WAYZATA PLANNING COMMISSION

Meeting Agenda

MEETING DATE: June 20, 2022	AGENDA ITEM: 5.a
TITLE: Consider Development Application for Wayzata Gateway at 900 Wayzata Boulevard East	
PREPARED BY: Valerie Quarles, Assistant Planner	
REVIEWED BY: Emily Goellner, Community Development Director	
60 DAY DEADLINE: August 1, 2022

**Staff Report
Wayzata Planning Commission
June 20, 2022**

DEMOLITION PLAN
C1.2

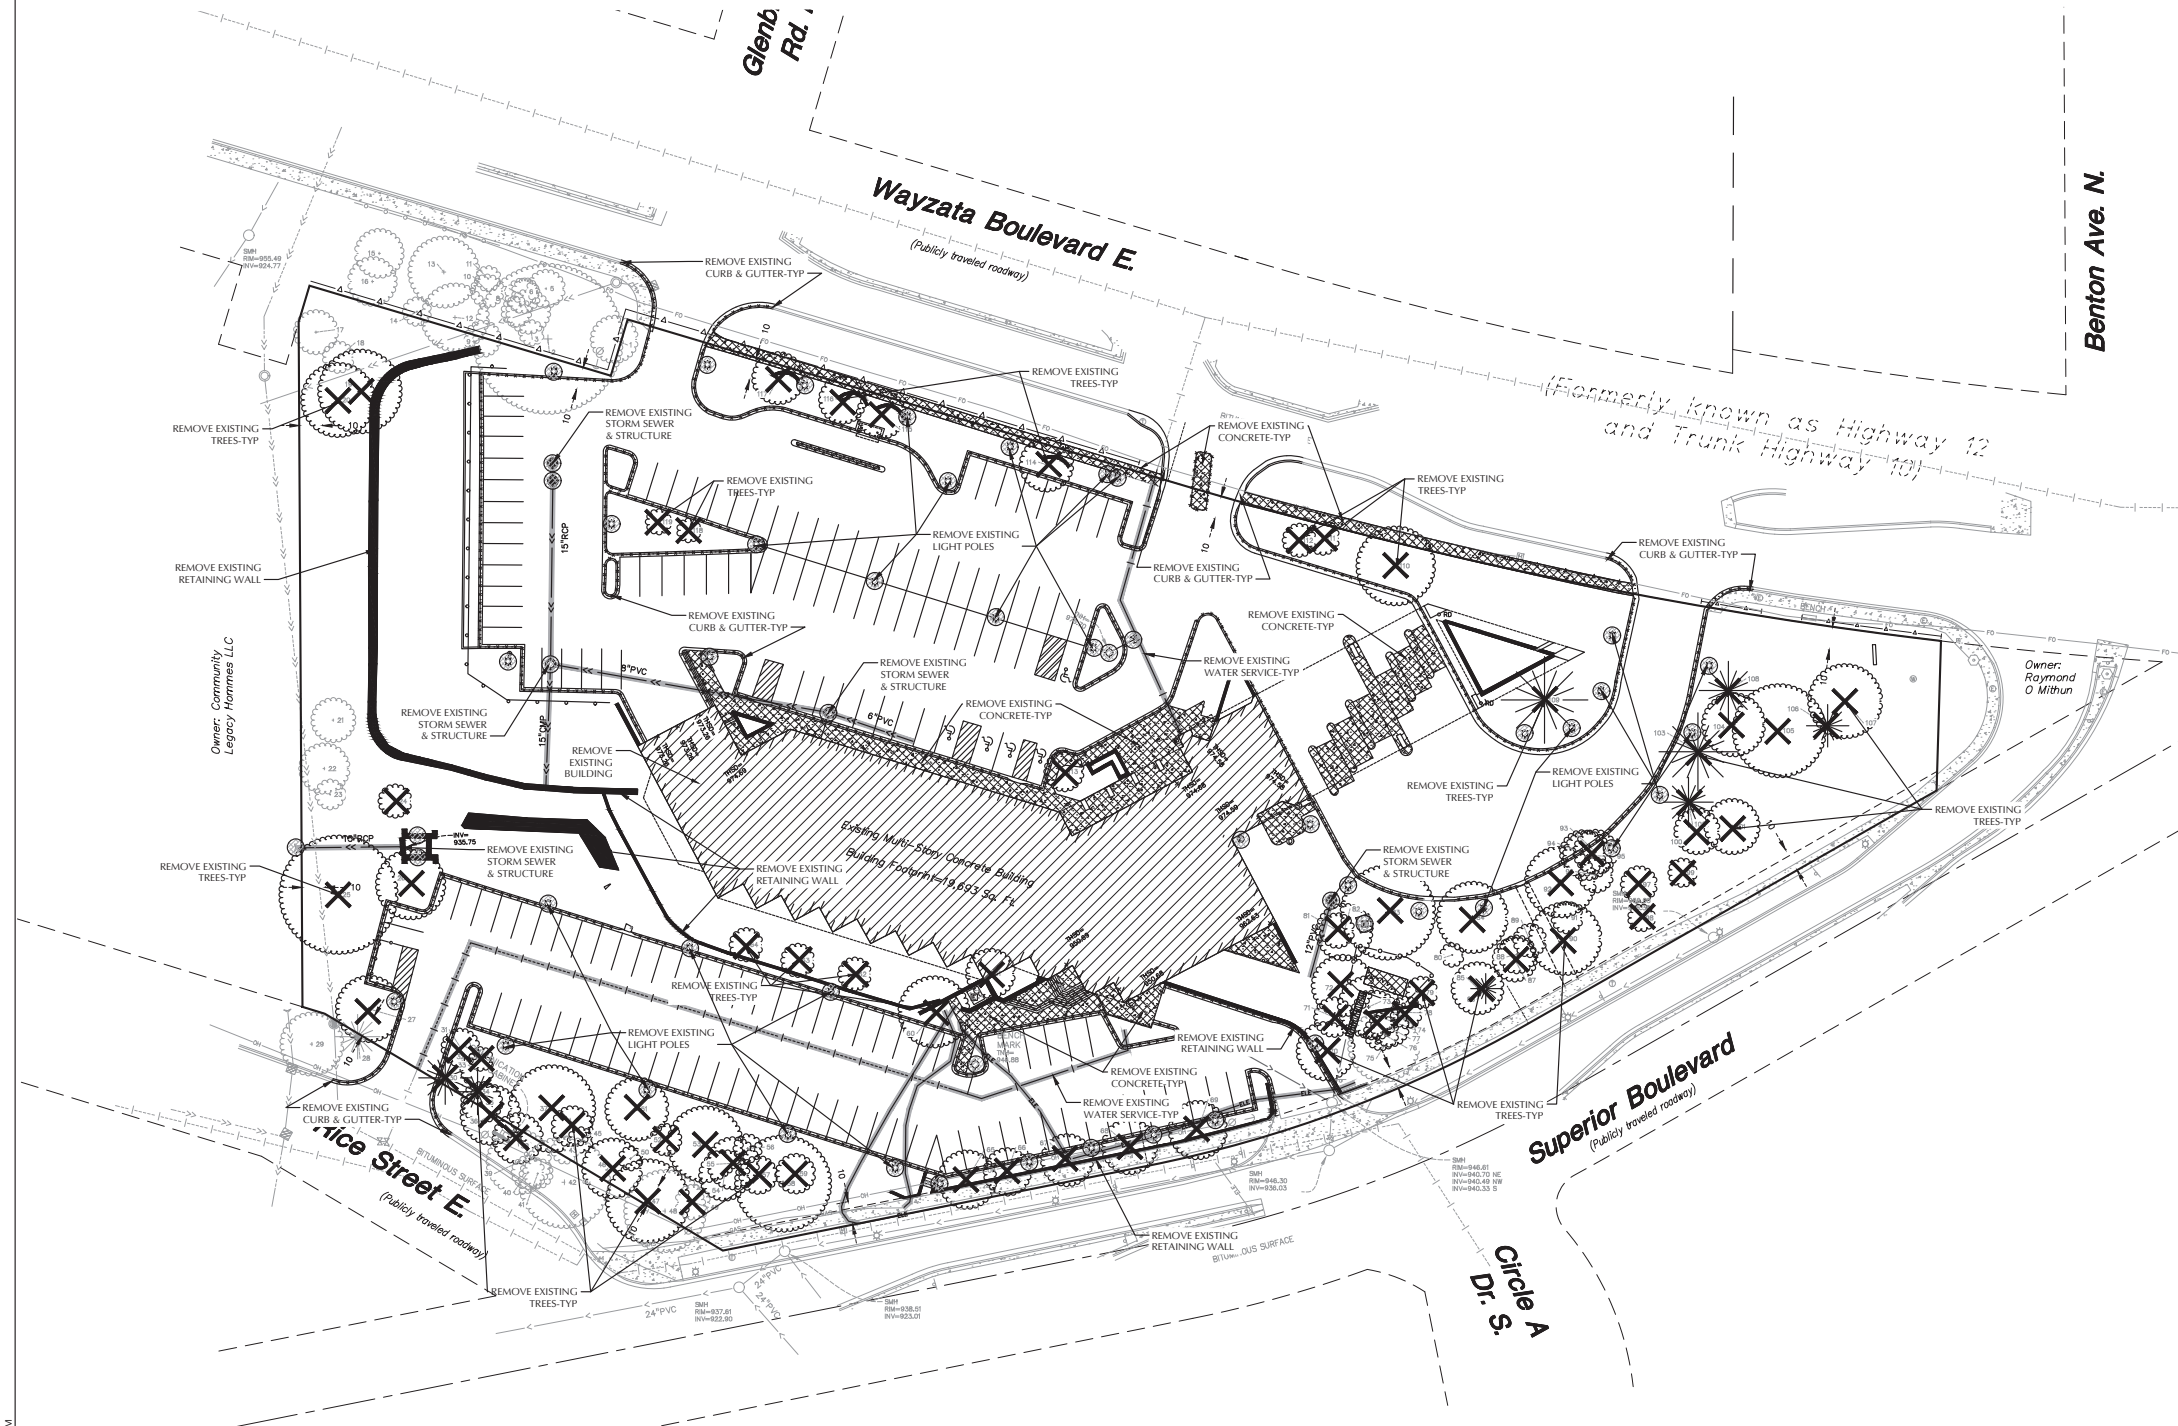
1. *Sheet C1.2 - Demolition Plan, Is there a full tree inventory sheet?*
Response:
Please see Alta/NSPS Land Title Survey/Tree Inventory Survey page 2 for full tree inventory. Included in this response.

2. *Sheet C1.2 – Demolition Plan, Are boulevard trees on Wayzata Blvd and Superior Blvd planned to remain? They are not shown on any plans and should be protected.*

3. *Sheet C1.2 – Demolition Plan, It appears one or two trees are planned to be removed from the Rice Street ROW.*
Response:
Plans will be updated to show the two trees in Rice Street ROW to be saved.

4. *Sheet C1.2 – Demolition Plan, Several of the trees to be saved along Rice Street and Wayzata Blvd are on City ROW. These should not be included in tree preservation analysis and calculations.*

Response:
Tree preservation analysis and calculations will be updated to remove the trees in City ROW.
5. *Sheet C2.1 – Site Plan, Parking stalls adjacent to sidewalks do not allow for two-foot (2') overhang of vehicles. Parking stall length should be increased to 20-feet or sidewalks should be widened to accommodate ADA required widths.*

SITE PLAN
C2.1

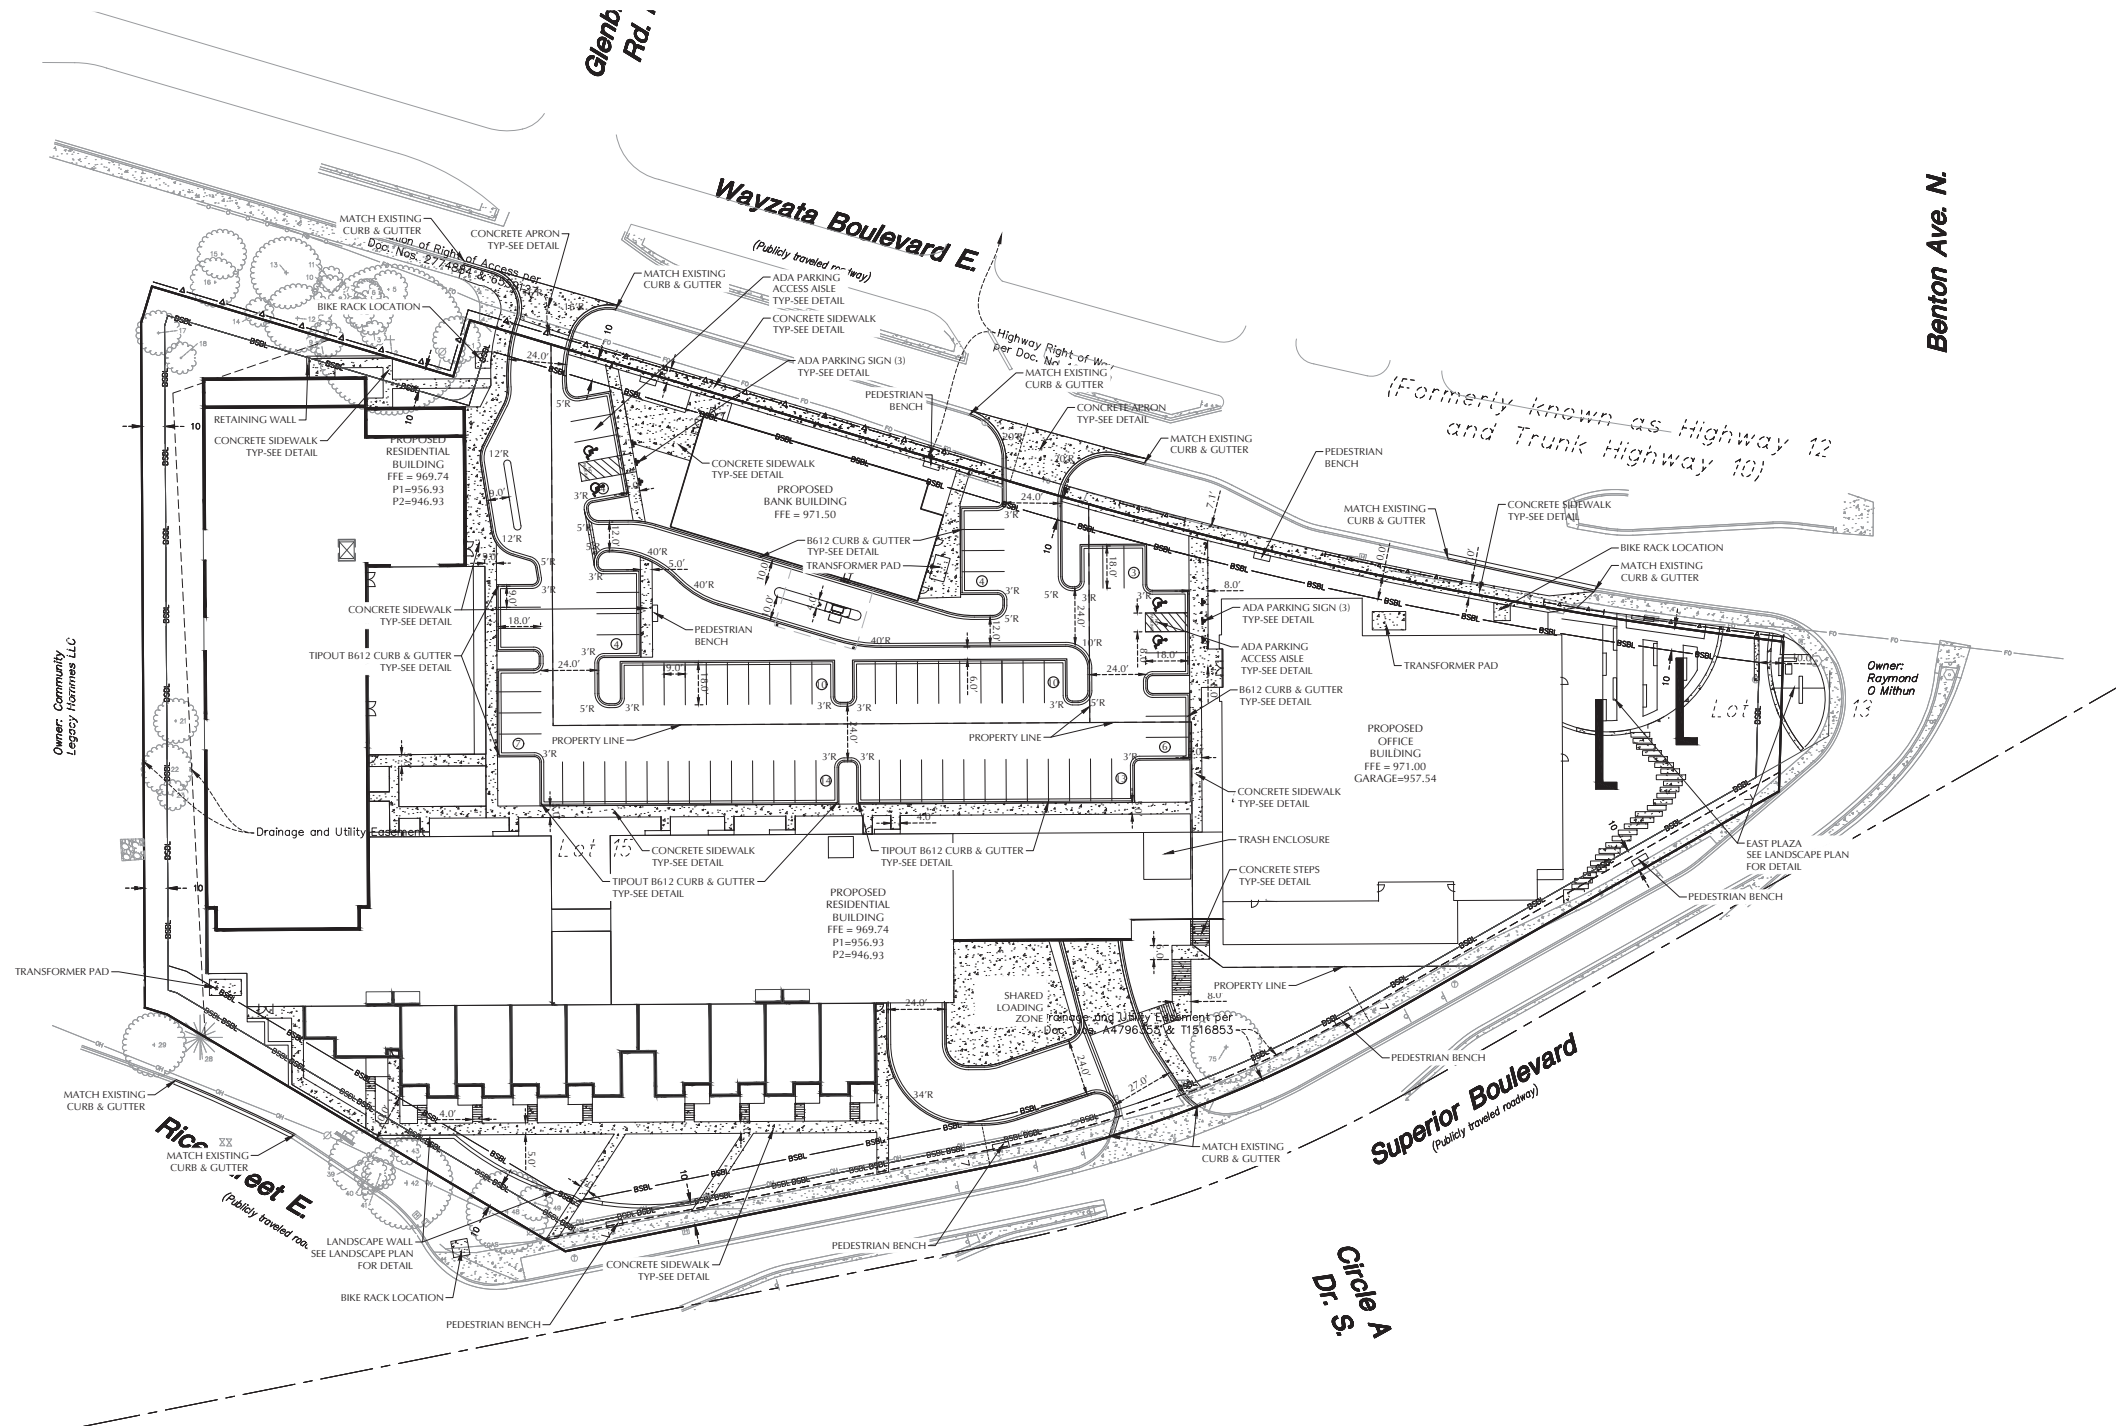
Response:
Team is studying this and will adjust the parking lot to meet this standard.
6. *Sheet C2.1 – Site Plan, ADA signage in front of east building may have same implications as listed above.*

Response:
Plans will be updated to shown ADA signage moved to back of sidewalk in front of east building.
7. *Sheet C3.1 – Grading Plan, Please provide proposed cut and fill quantities.*

SWPP PLAN
C3.2

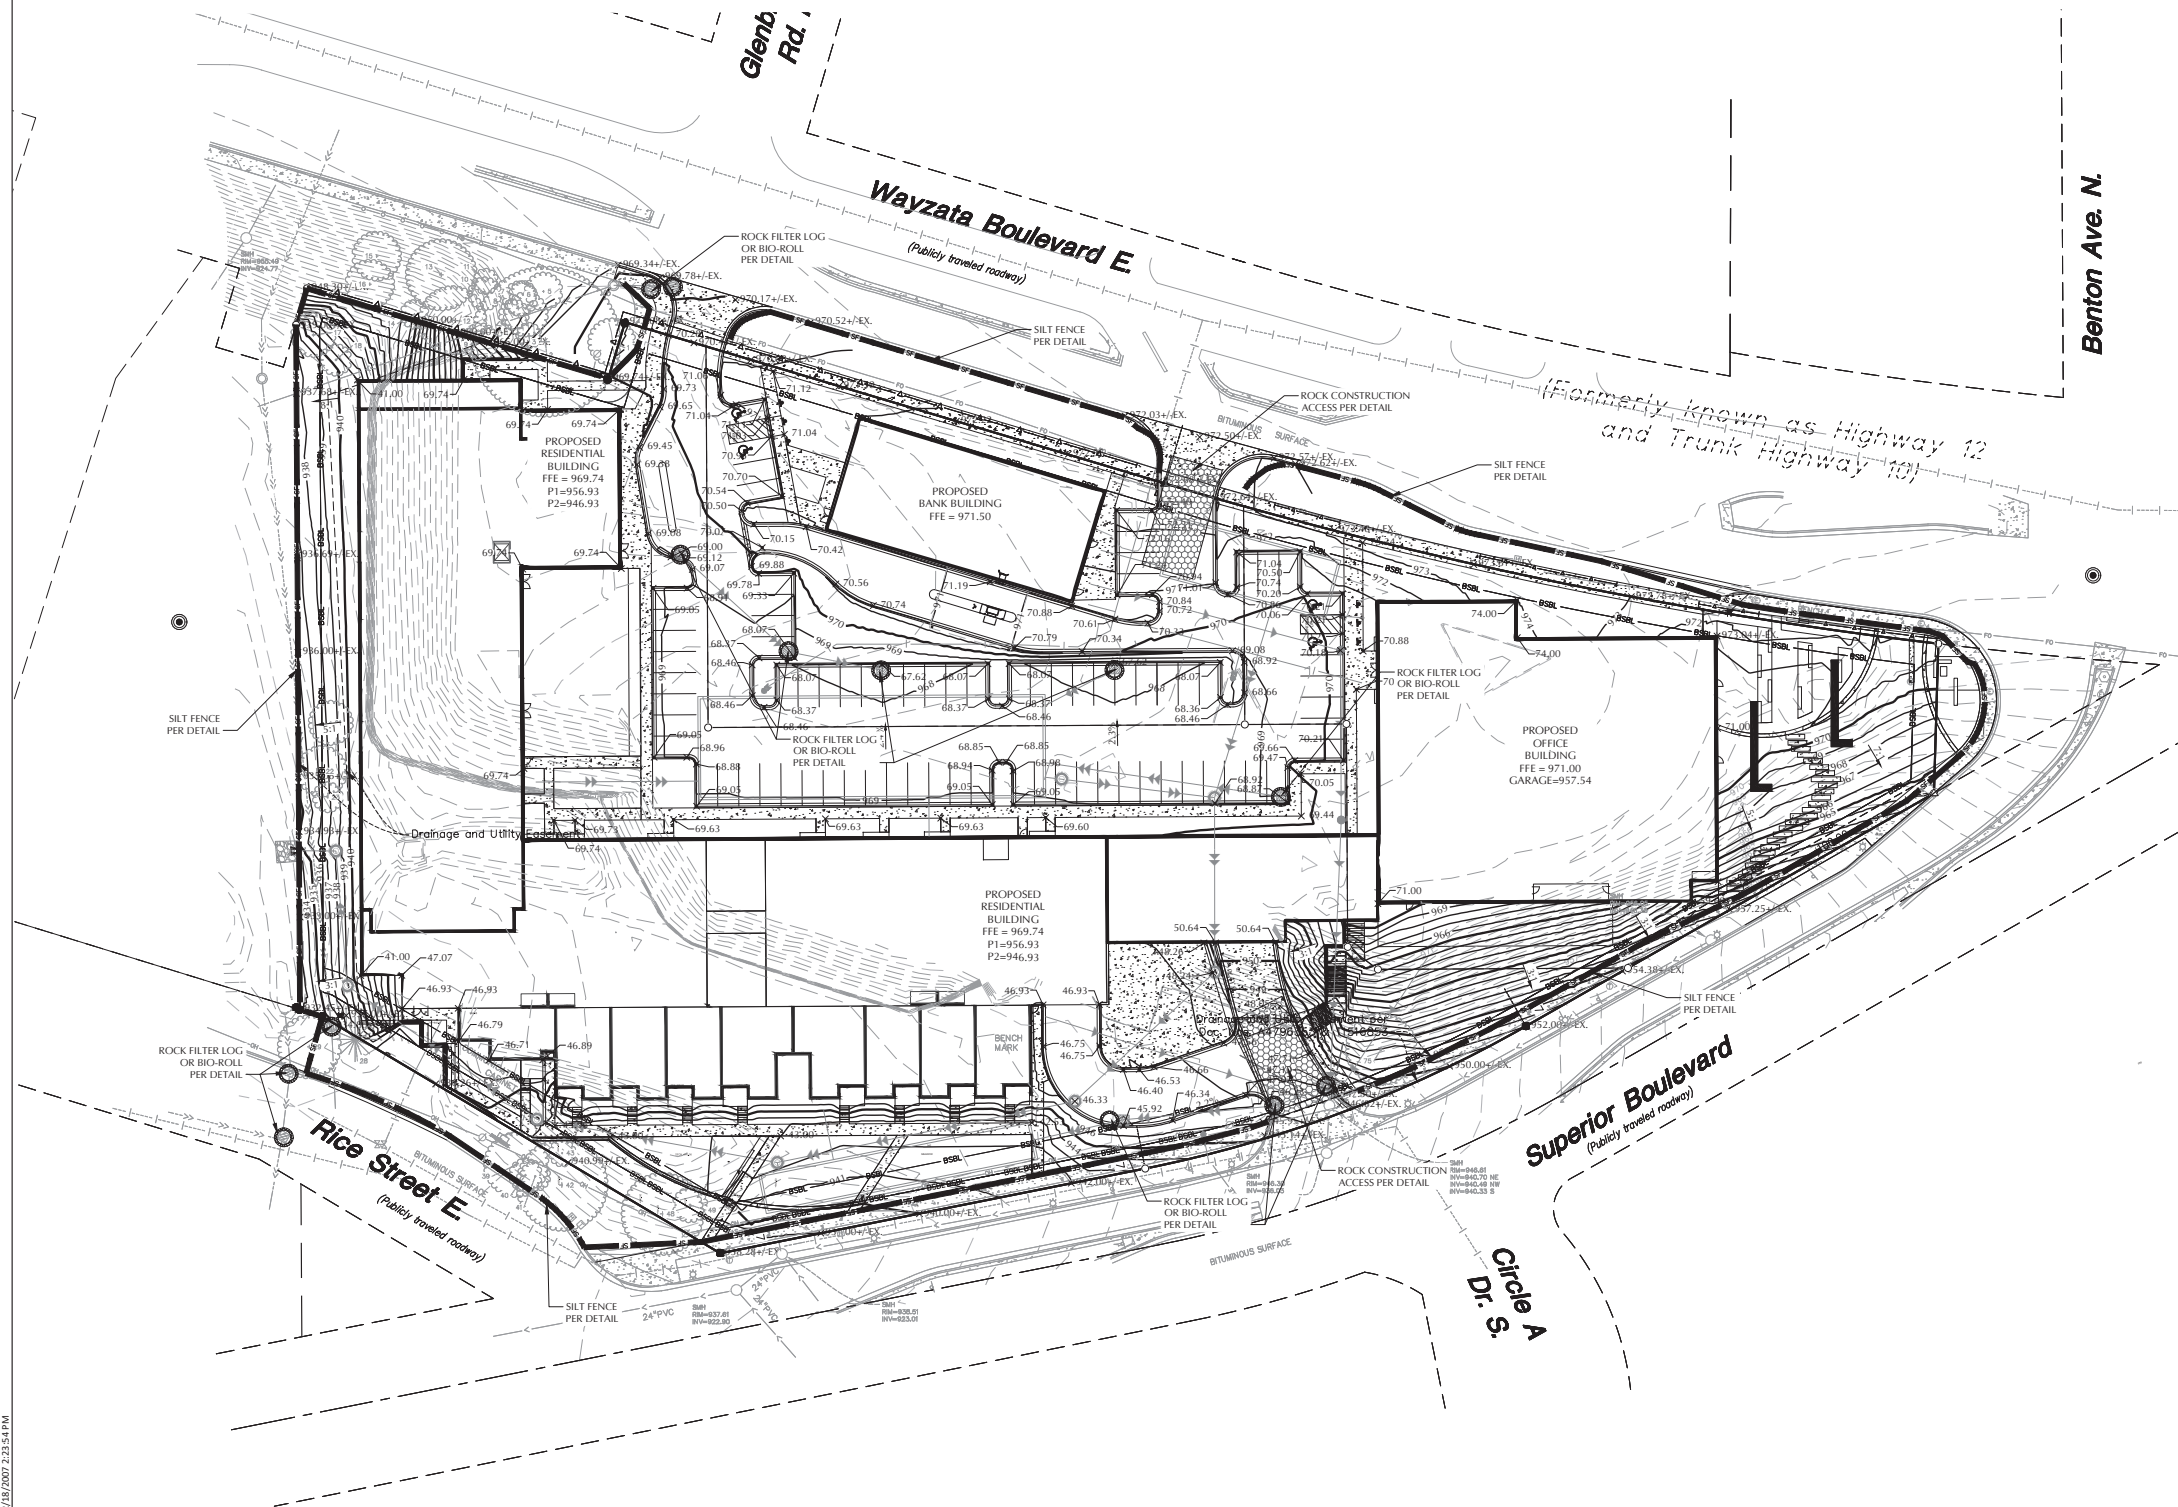
8. *Sheet C3.2 – SWPPP, Grading appears to be occurring outside of proposed silt fence along Superior Blvd.*

9. *Sheet C3.2 – SWPPP, Inlet protection should be provided in CB on Superior Blvd, southwest of Rice Street.*
